SUBSURFACE WASTEWATER DISPOSAL SYSTEM APPLICATION

JENNIFER SANBORN
REPLACEMENT SYSTEM VARIANCE REQUEST

System's Location: 380 Pleasant Avenue, Peaks Island

SUBJECT: Approval, Replacement System Variance Request, Axiotis property, Peaks Island

SUBSURFACE WASTEWATER DISPOSAL PLAN

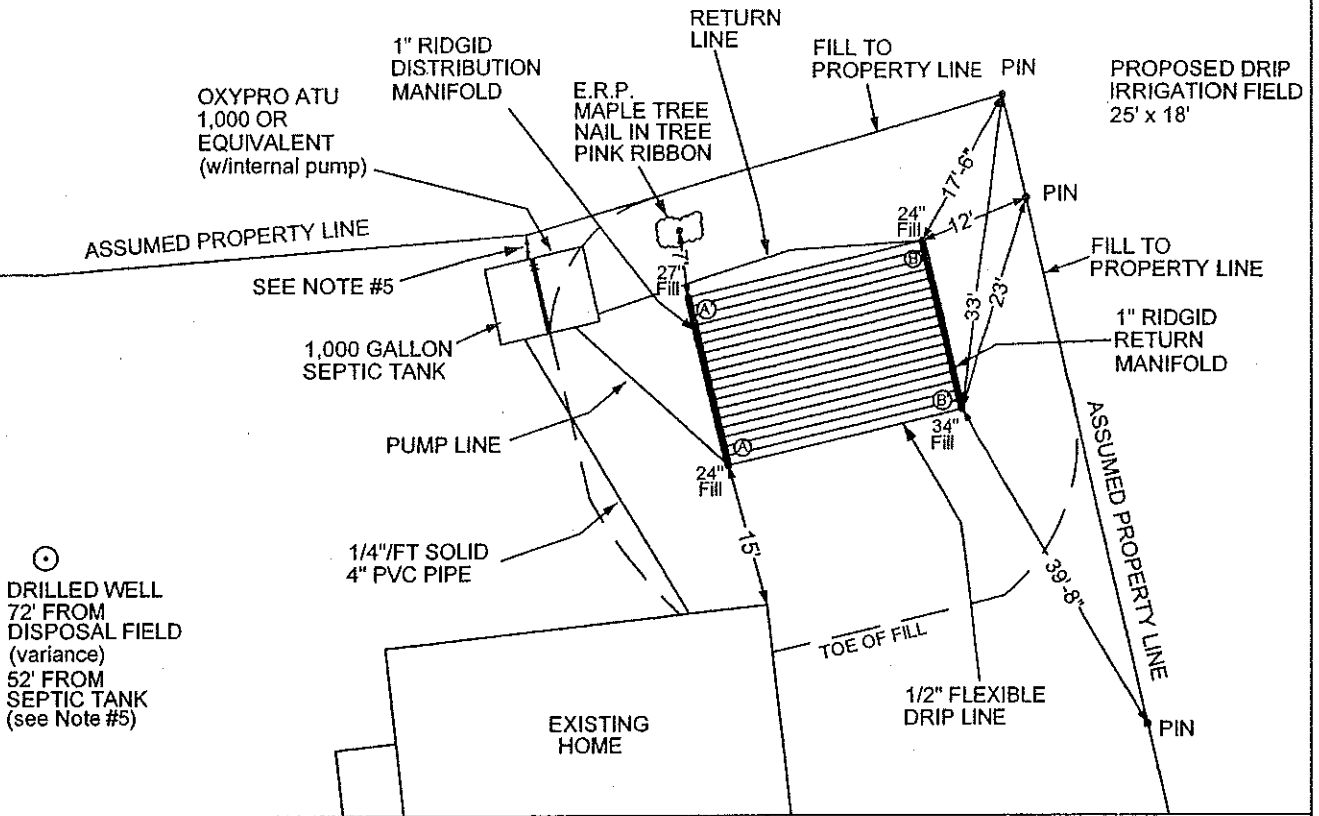
Comments: No PRACTICAL LOCATION FOR TANK

2. Existing well is 72' from the proposed disposal field (requires variance approval from the Local Plumbing Inspector (LPI)). Resident of home, Sophia West, was notified that the proximity of the well to the disposal field might increase the potential of well contamination.

Comments: No PRACTICAL LOCATION FOR TANK

The Division has reviewed a replacement system variance request for the subject property. The state variance requested is to install the system with a setback distance reduction from your well to the disposal field of 72 feet, a setback distance reduction from a slab, frost wall, or columns to the disposal field of 14 feet, a setback distance reduction from a property line to the septic tank of 0 feet, a reduction in depth to the seasonal high ground water table from 12 inches to 0 inches, a reduction in depth to bedrock from 24 inches to 1 inch, and a fill extension grade to 3:1 as needed to keep fill from crossing the property lines. As we understand the situation, the variance request has been submitted because topography and existing development limit the potential system location. The system design prepared by Andrew Gobeil, SE, dated 09/18/2005 is otherwise found to be in compliance with the Maine Subsurface Wastewater Disposal Rules.

We approve the requested variance with the following requirements:

1. A permit for system installation is to be obtained from the Local Plumbing Inspector in advance of the start of system construction.
2. The system is to be installed in accordance with the submitted and approved system design. Should alterations to the design be required at the time of construction, the site evaluator is to be notified prior to making any changes.
3. The contractor is to scarify the soils under the fill extensions to create a transitional zone more compatible with the disposal field area.
4. The septic tank to be installed shall be monolithic.
5. No fill shall cross over the property lines unless a legal easement is granted by the abutting property owners.
